Red-Line Revision 1

MARYLAND DOT - STATE HIGHWAY ADMINISTRATION
Office of Traffic & Safety
TRAFFIC ENGINEERING DESIGN DIVISION
(Traffic Signal Plan)

US 1 (Baltimore Ave) at Cherry Hill Road

MAST ARM DETAIL
Not to Scale

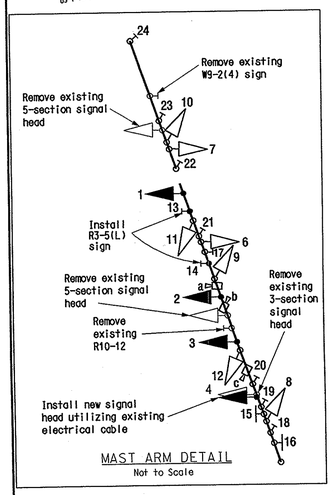
EXISTING SIGN TO BE REMOVED

W9-2(4) 42" x 30" (LANE ENDS MERGE LEFT)
R 10-12 30" x 36" (LEFT TURN YIELD ON GREEN)

EXISTING SIGNALS TO BE REMOVED

12"/8"
12"

PROPOSED SIGNALS

1,2,5 — 12" L.E.D.
3,4 — 12" L.E.D.

PROPOSED SIGNS

13,14 — R 3-5(L) 30" x 36" (ONLY)

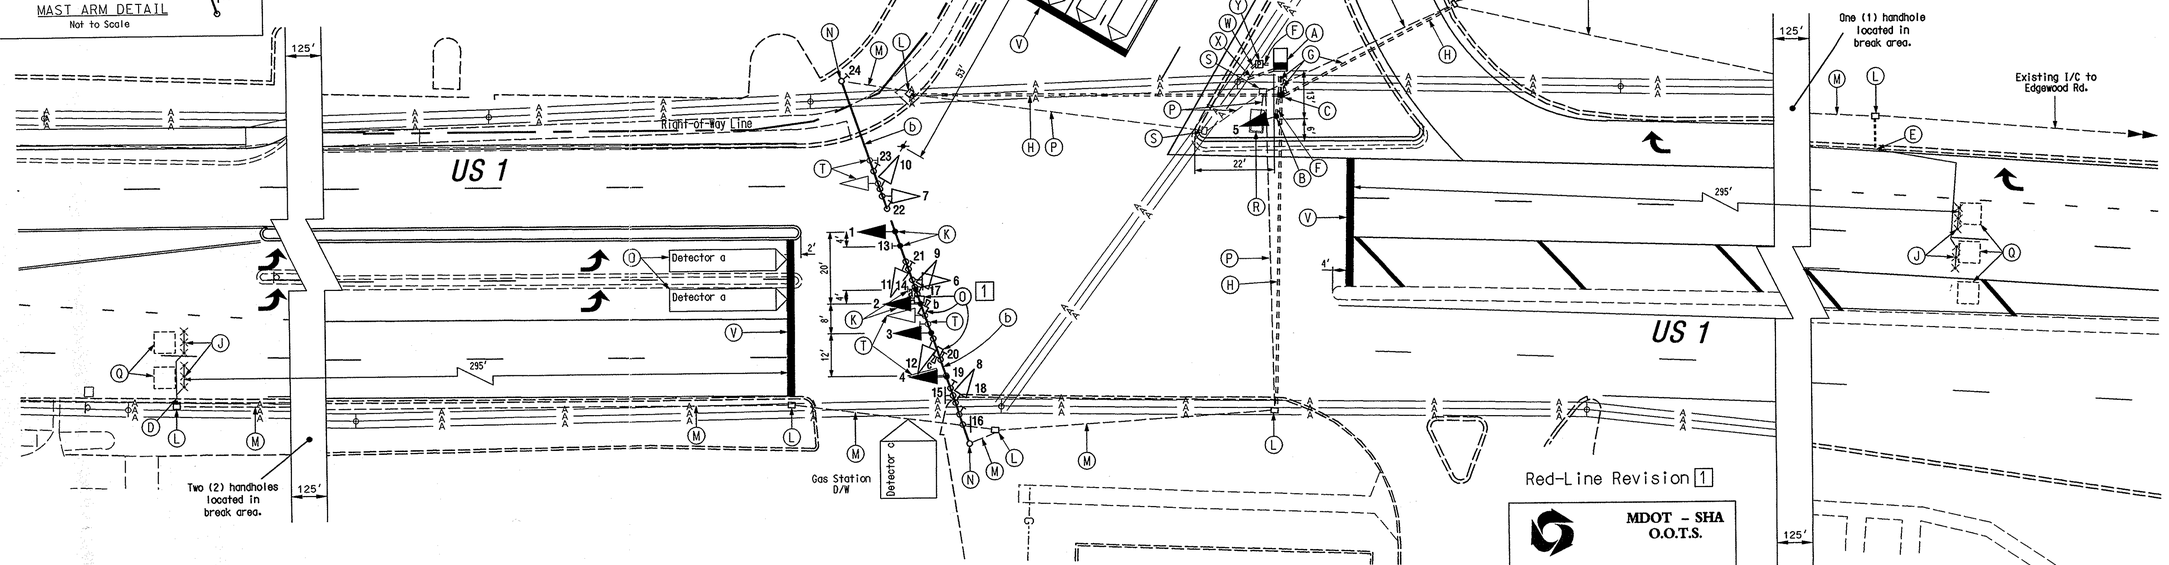
A. Install base mounted NEMA 6 cabinet. Relocate existing controller and detection equipment to new cabinet.
B. Install 14 ft. steel pedestal pole on break away base with signal head (Note: one 2 in. PVC conduit bend).

C. Install handhole.
D. Install 1 in. liquid tight flexible conduit for loop detector lead-in.
E. Install 1 in. galvanized steel conduit for loop detector lead-in.

F. Install 2 in. polyvinyl chloride [Schedule 80] electrical conduit - trenched.
G. Install 4 in. polyvinyl chloride [Schedule 80] electrical conduit - trenched.

H. Install 4 in. polyvinyl chloride [Schedule 80] electrical conduit - bored.
J. Install mirco-loop probe (set of 3).
K. Use existing mast arm. Install signal heads and signs as shown.

L. Use existing handhole.
M. Use existing conduit.
N. Use existing steel pole.
O. Replace existing camera. Realim for proposed detector zone.
P. Cap and abandon existing conduit.

Q. Abandon existing loop detector.
R. Remove existing cabinet.
S. Remove existing handhole.
T. Remove existing signal heads and signs (See "Mast Arm Detail" this sheet).

U. Use existing handhole. Pull back existing I/C and rerun in new conduit to new cabinet.
V. Proposed pavement markings to be installed by others.
W. Install 4 in. conduit for an underground electrical service by PEPCO.

X. Install 2 in. conduit for phone service by Verizon.
Y. Install electrical service pedestal (200 amp), and necessary equipment for an underground electrical MD-SHA Type 807.05-01 service.

Z. Install non-invasive micro-loop probe (set of 3).
a. Install 2 in. polyvinyl chloride [Schedule 80] electrical conduit - bored.
b. Use existing mast arm. Rewire signal heads as shown on wiring diagram.
